**CITY OF TEMPE
DEVELOPMENT REVIEW COMMISSION**

**Meeting Date: 01/14/2020
Agenda Item: 10**

ACTION: Request a Use Permit Standard for side yard setback reduction from 10' to 8' and a Development Plan Review for four new single-story single-family homes for 19TH STREET RESIDENCES located at 667 West 19th Street. The applicant is Habitat for Humanity.

SITE PLAN FOR 19TH STREET HOMES 19TH STREET AND MCKEMY STREET

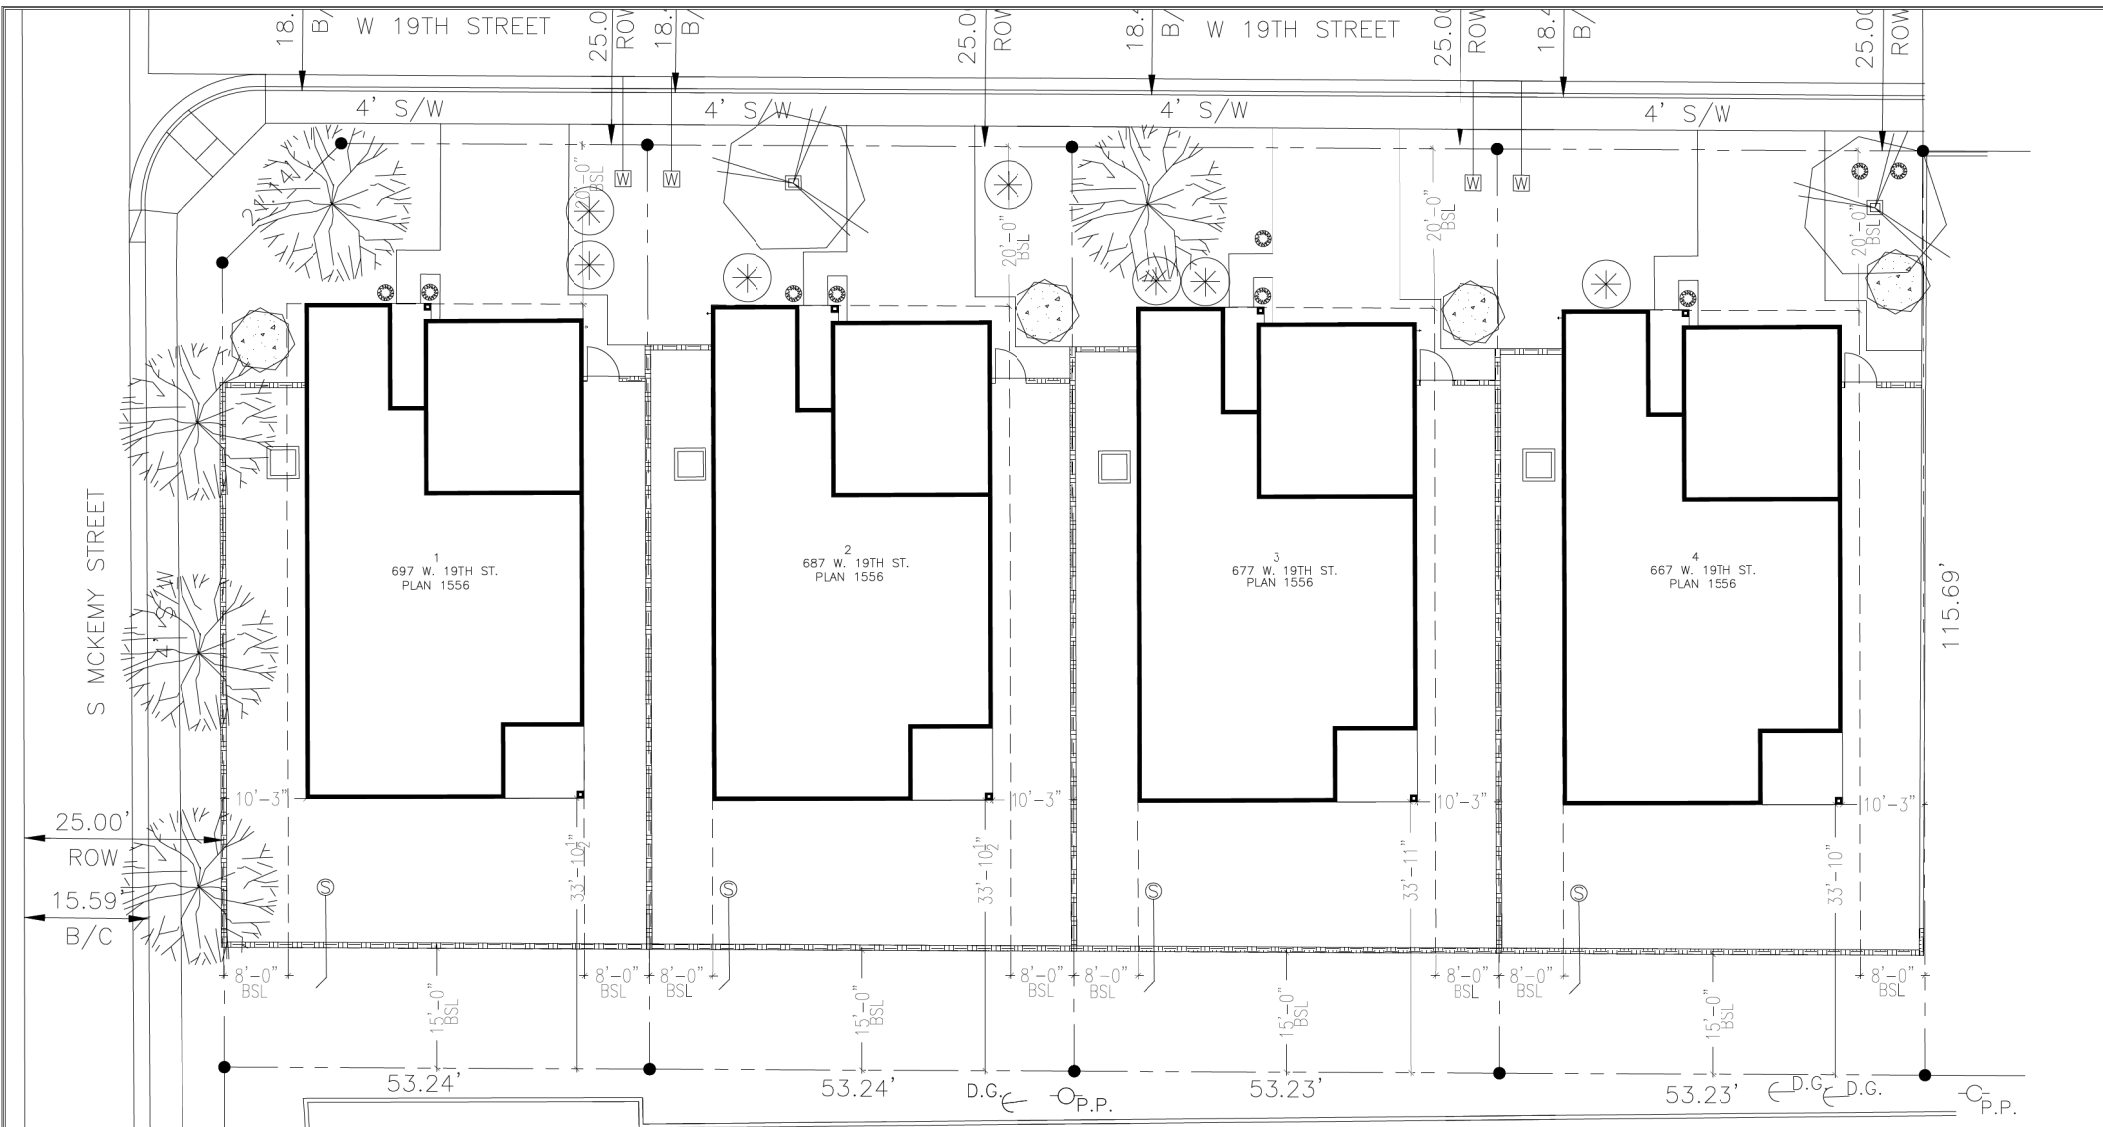
The proposed design requires a Use Permit Standard to reduce the side yard setbacks from 10' to 8' within the R-3 Multi—family Limited zoning district. The homes are 35' wide, requiring encroachment of 2' on one of the side yards of each lot. The width increase in the building footprint was necessary to accommodate a garage and a single-story residence.

LANDSCAPE PLAN
HABITAT FOR HUMANITY
 TEMPE, AZ 85281
 CENTRAL ARIZONA
 9133 NW GRAND AVE
 PHOENIX, AZ 85045
 O: 623.583.2417
 ROC 251891

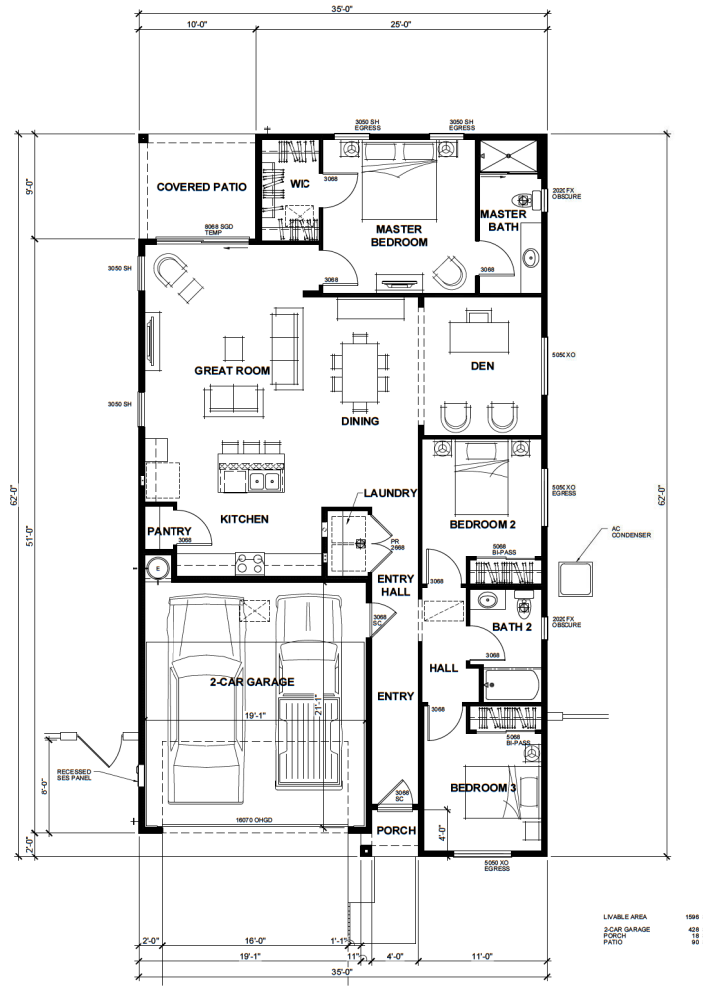
6. Although the color elevations showed lush plants at the base of the building, the landscape plan did not include these plants or meet design standards for front yards. Trees are only 10.5 gallon and yards are predominantly gravel. Staff has conditioned the landscape plan to include 1 ½" caliper trees and a palette option for a mix of ground cover and shrubs to provide more vegetative ground cover.

8. Recommendations were made for the planting plan, but the landscape plans did not provide sufficient plant variety or quantity to meet design criteria.

The landscape plan provides residents with a choice of two trees, either Thornless Mesquite or Palo Verde, the plan has a choice of two shrubs, Cassia or Sage, and one ground cover, Red Yucca. Staff has conditioned the proposed planting plan to provide more biodiversity and more vegetative ground cover.

8. Each lot owner shall be given the choice of four of any of the following combinations of 3-5' shrubs: Silver Cassia, Texas Sage, Tecoma stans 'sparky', Ruellia peninsularis, Bougainvillea, Mexican Bird of Paradise, Eremophila valentine and/or Hop bush.

9. Each lot owner shall be given the choice of seven of any of the following combinations of 2'-3' ground covers: Red Yucca, Eremophila glabra, Muhlenbergia, Rosemary, Gold Lantana, Bush Morning Glory, Acacia redolens.

10. The McKemy Street side yard shall have three street trees of one of the following species, per the owner's selection: either Evergreen Elm, Chinese Pistache or Heritage Oak, and shall be a minimum of 1 ½" caliper.

11. The McKemy Street side yard shall have three shrubs from the 3-5' plant list of the owner's choice, spaced between the trees along the west side of the wall and three ground covers from the 2' plant list planted at the corner of the lot at the intersection of the streets adjacent to the sidewalk; these six plants are located within the right of way and are in addition to the front yard landscape.
